# SAFETY RECALL BULLETIN NHTSA RECALL 19V277, Transport Canada 2019212

**AUTOCAR, LLC SAFETY RECALL ACX-1904**

Autocar has determined that a safety issue may exists with the brake chamber hardware due to the absence of a clevis pin on certain 2019-2020 model year Xpeditors.

Figure 2

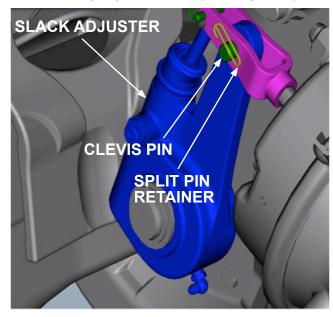
3. Inspect for the presence of the clevis pin and a split pin retainer (see Figure 2).

Note: If any defects, worn ,damaged or missing components are found or if you have any questions or difficulties regarding this recall, please contact Autocar technical support at 888-218-3611.
